Technical Service Bulletin

**Solitude 360RL Slide Room Flex-Guard Strap -
DS Dinette Slide**

16-005

Solitude 360RL

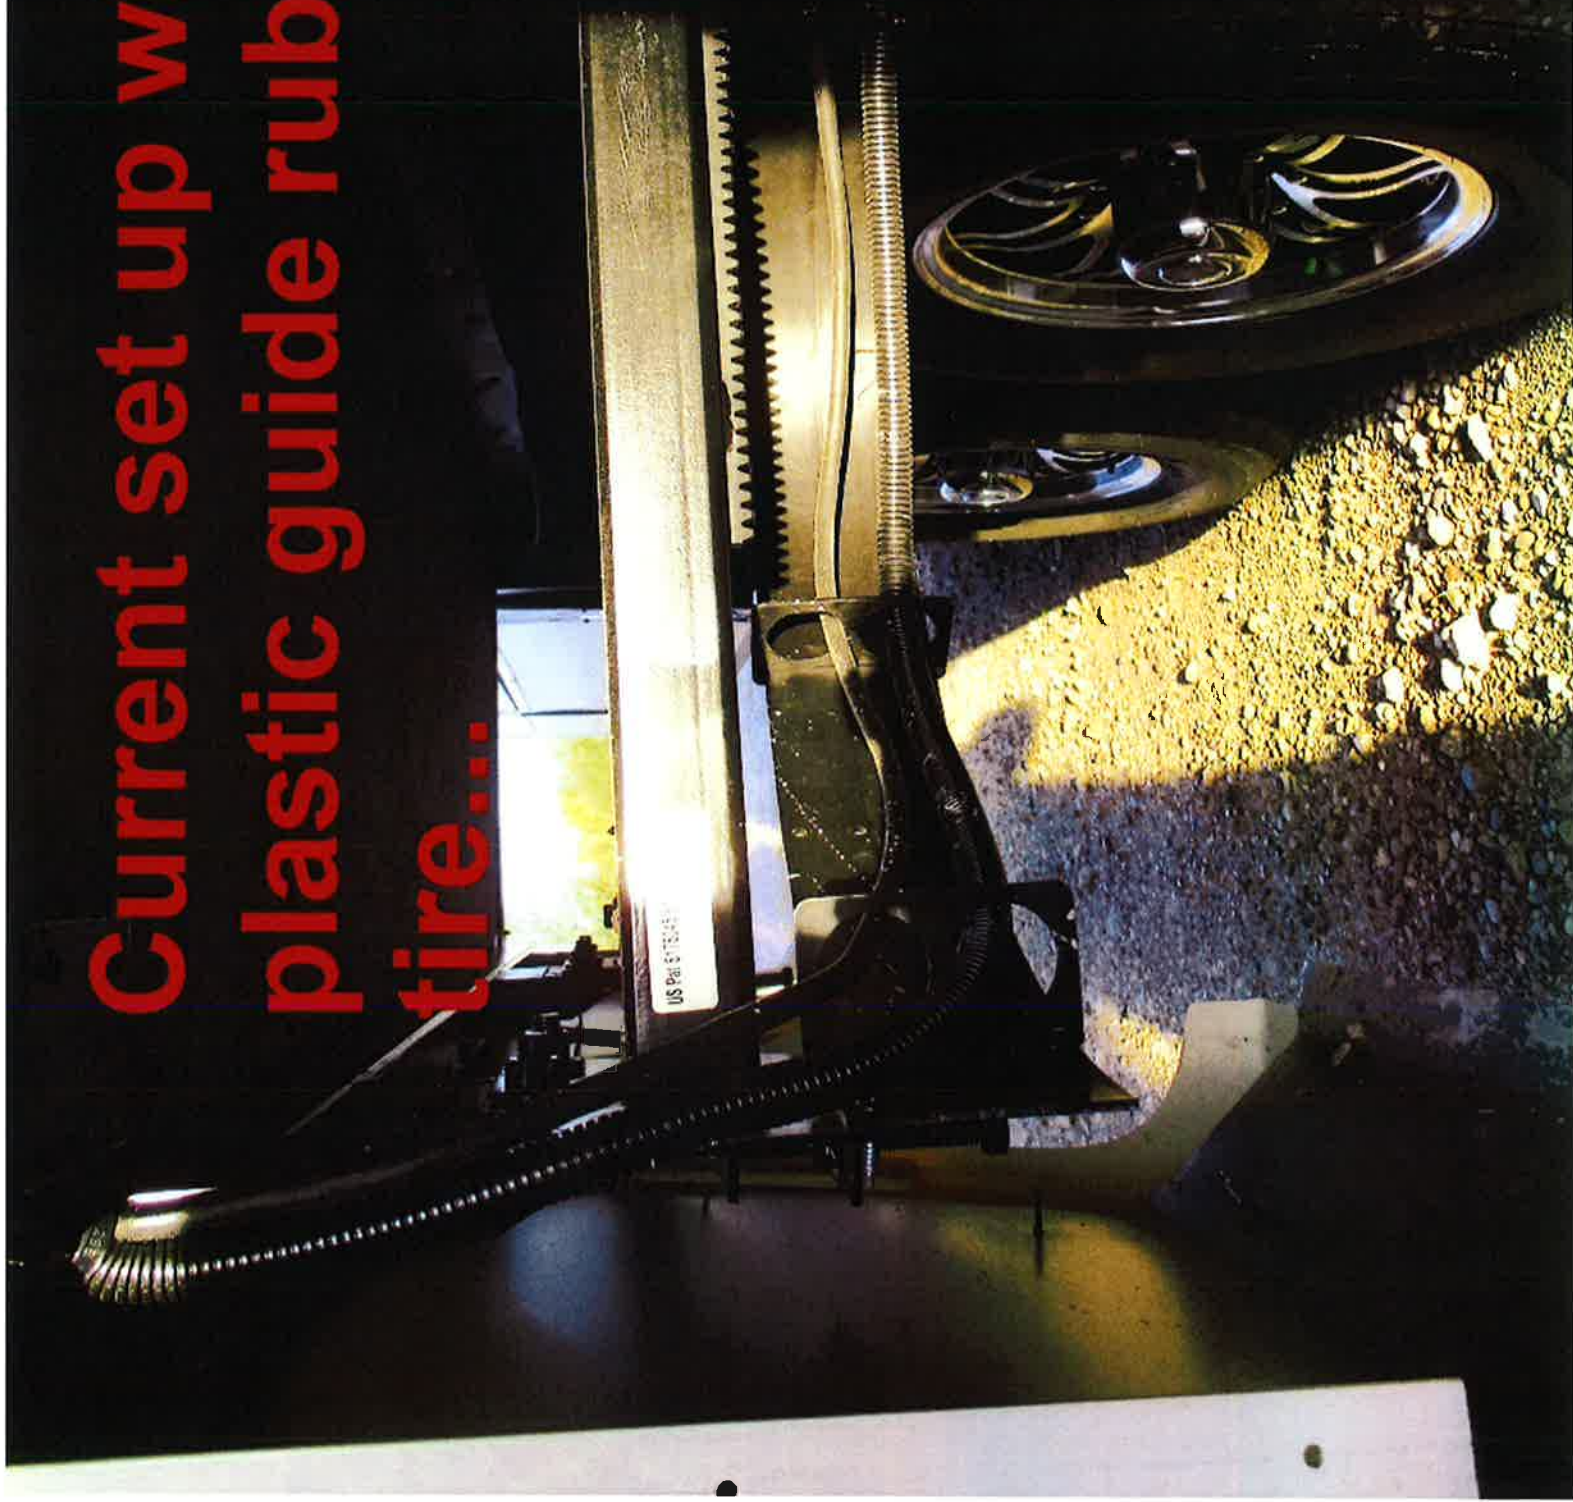
Under the door-side slide out and in the travel mode, the plastic wire guide/belt could fall within 2-3" of the front tire, which is inside the minimum required distance of 4".

Current set up with
plastic guide rubbing
tire...

Replace the existing plastic wire guide with the current spring-type guide Reflection is using. This will allow the space needed between the wires and tires when the slide out is in the travel mode.

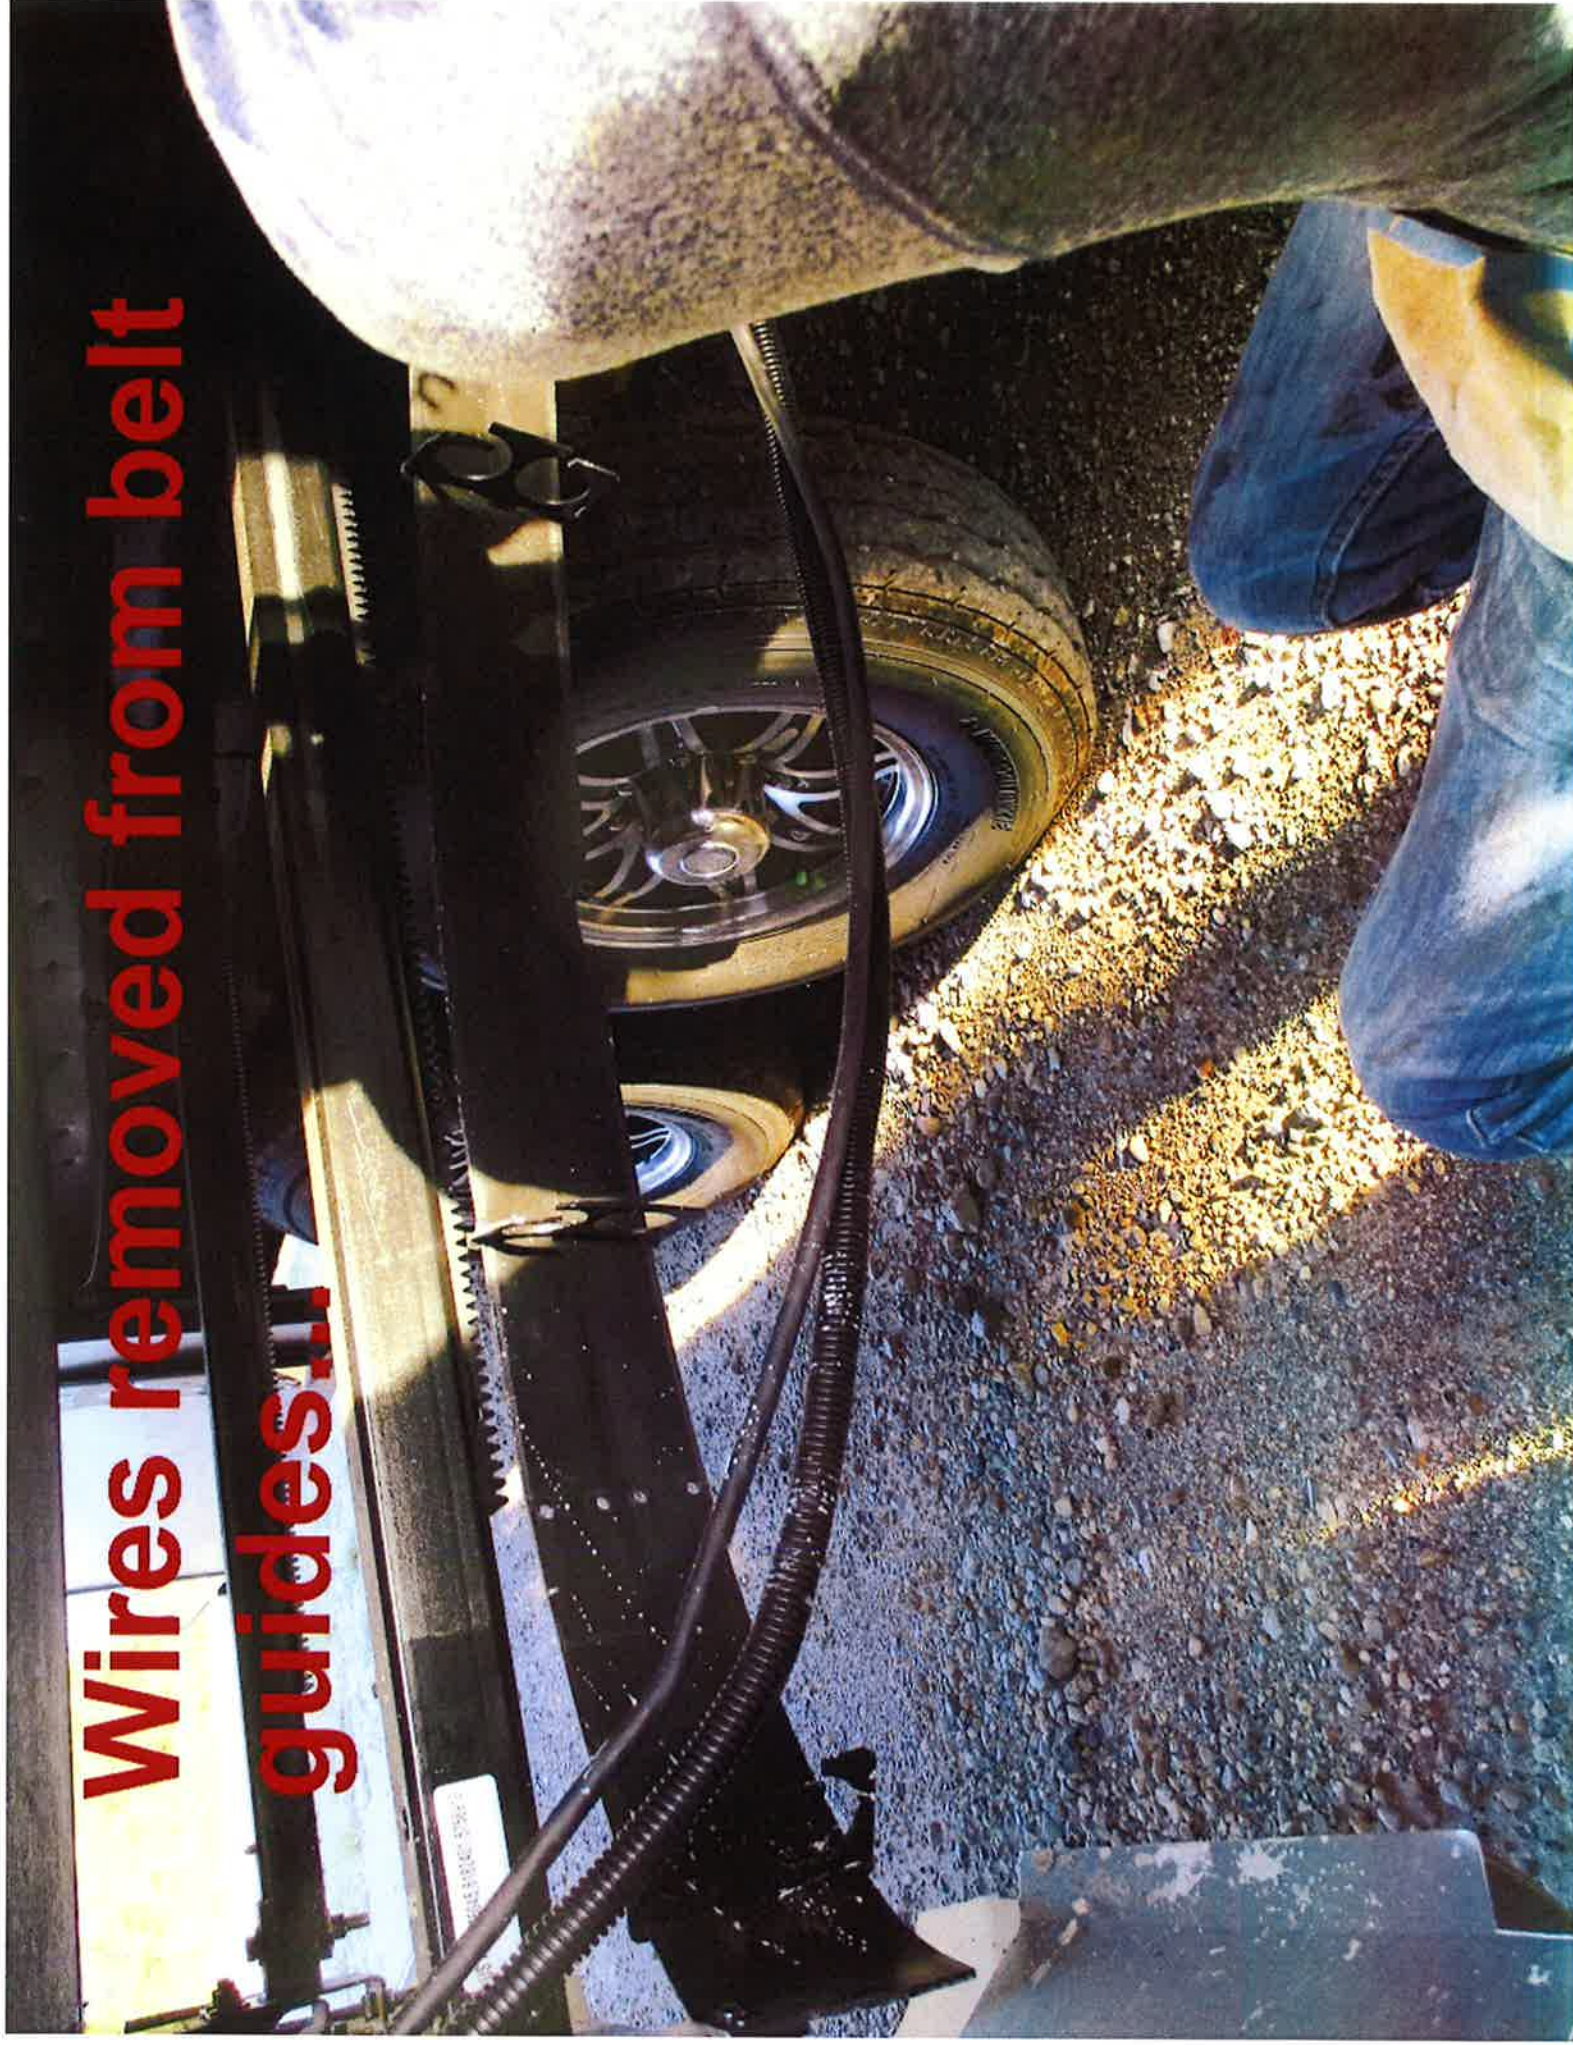
**With snips, cut
guides to allow
easy removal of
wires and belt...**

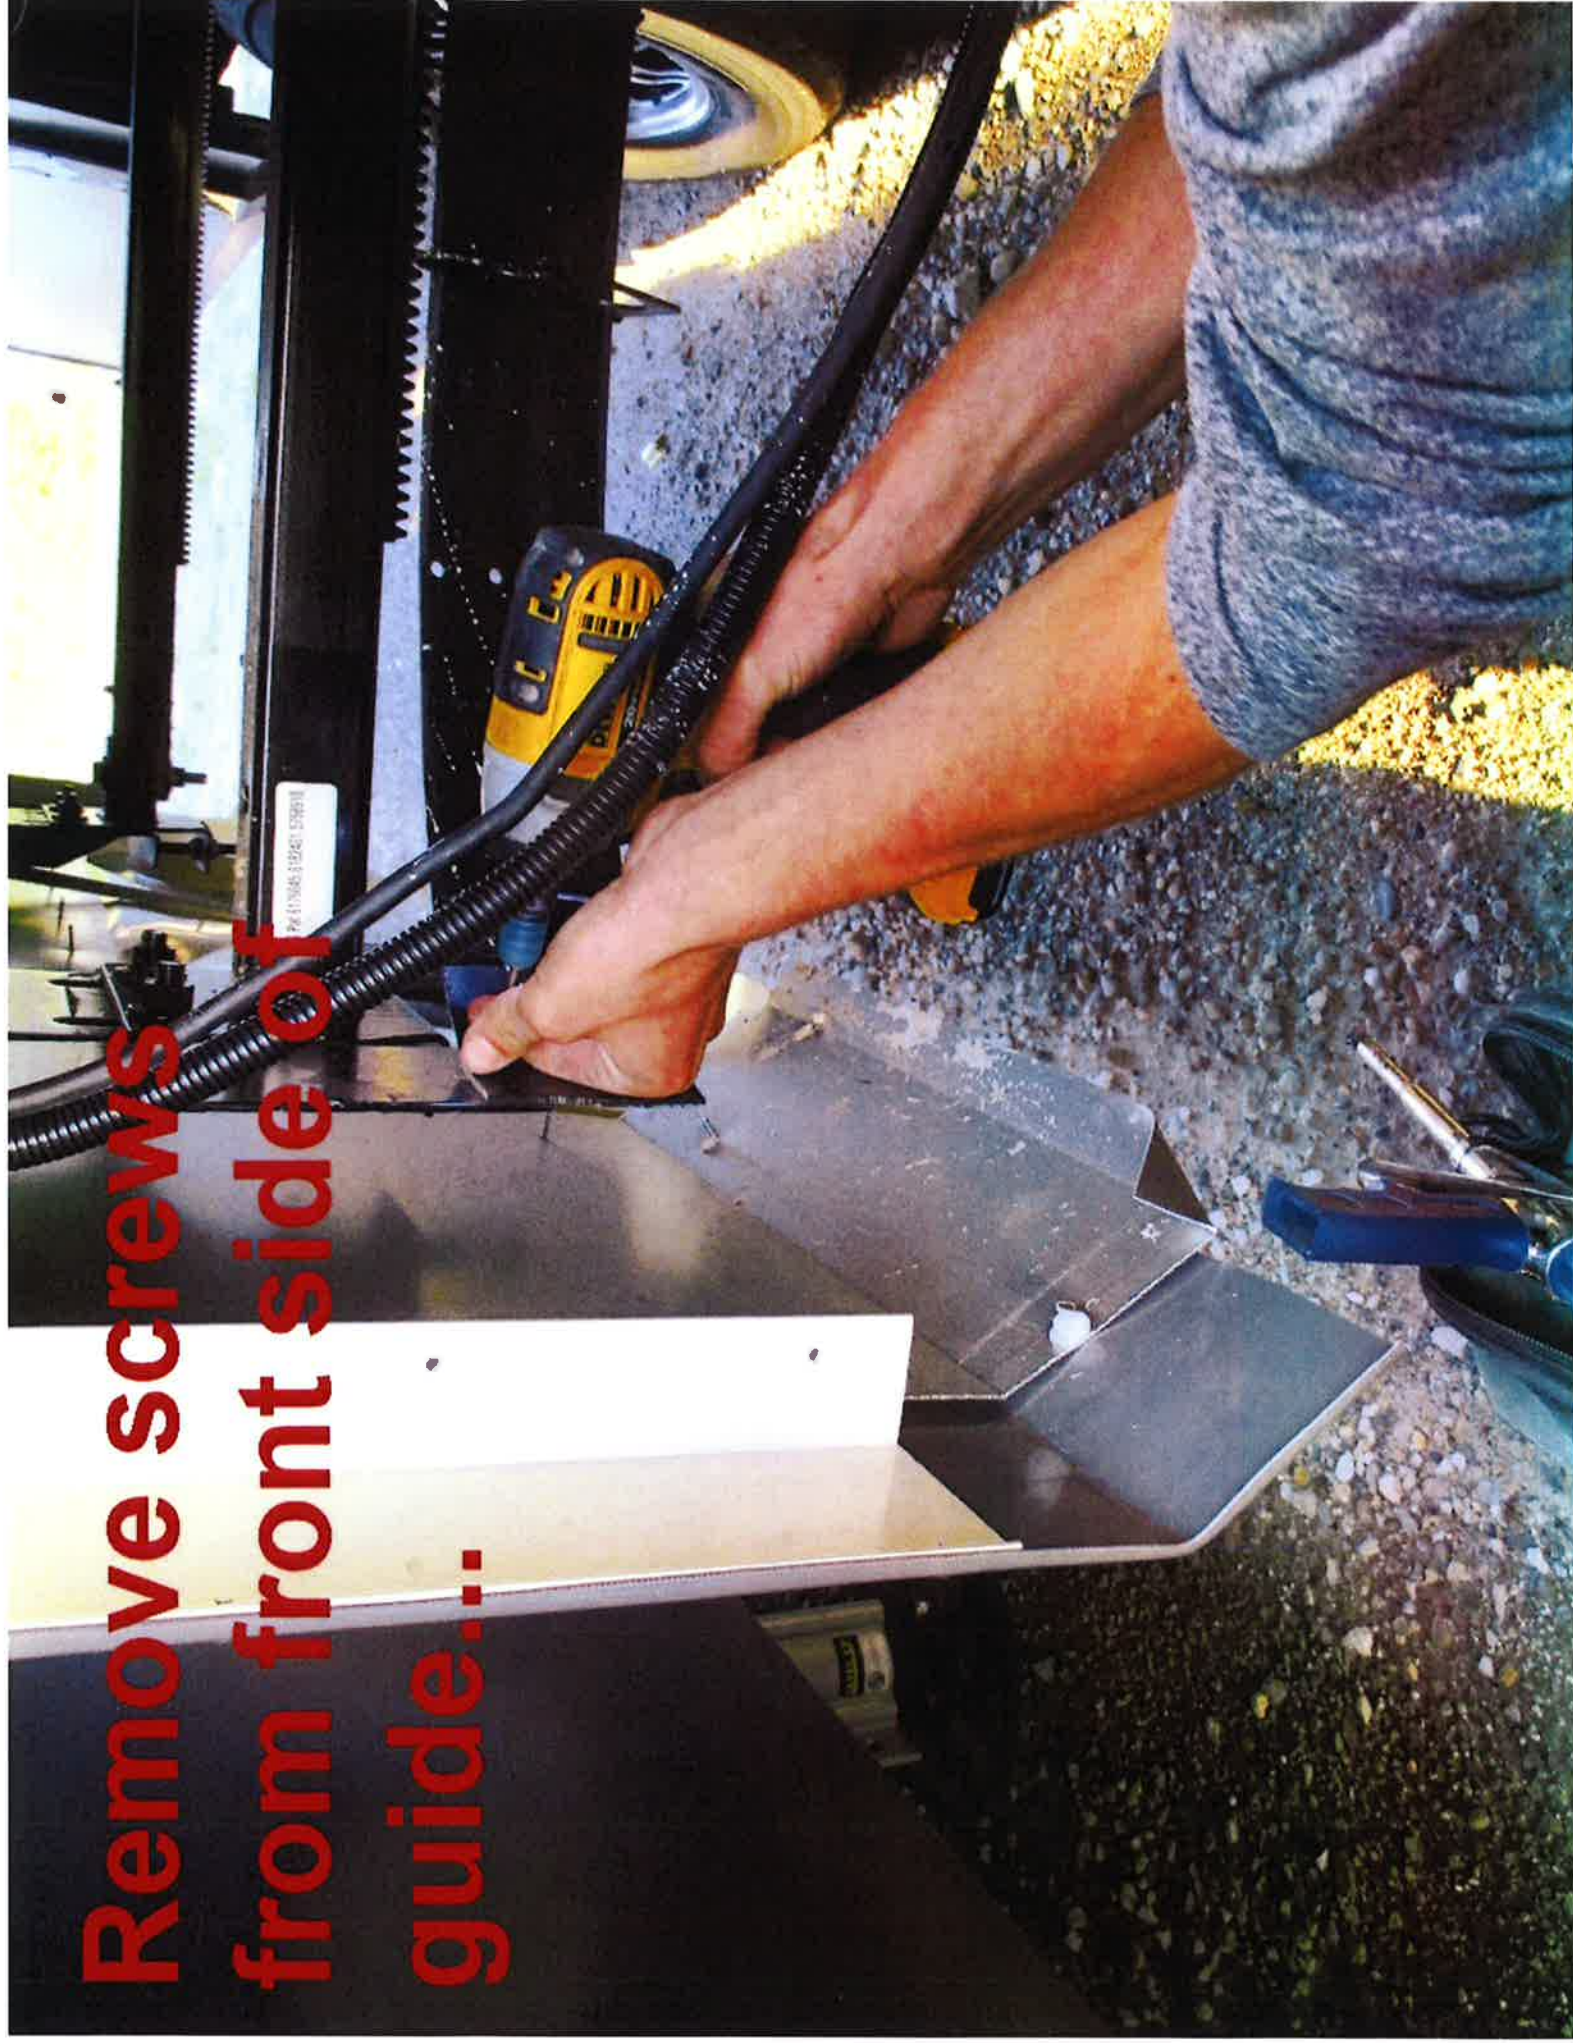
**Wires removed from belt
guides...**
